State of West Virginia  
 Request for Quotation  
 09 — Construction

Doc Description: Addendum No. 02-Building 3 Demountable Partitions Project

**Technical Questions for CRFQ GSD1700000007  
Demountable Partitions for Bldg. 3**

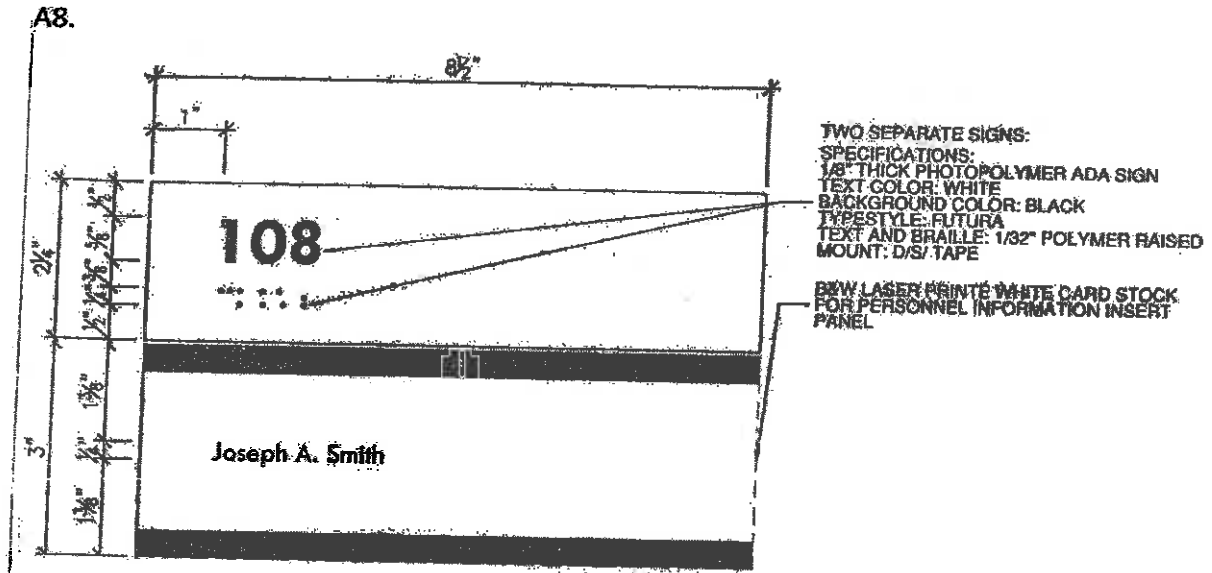
1. Provide answers to vendor-submitted Technical Questions, including Appendix A8 (Sketch A8, regarding signage & Technical Question #8).

8. Signage – Please provide size, font, color and the type of sign specified.

**Answer:** See attached Appendix A8.
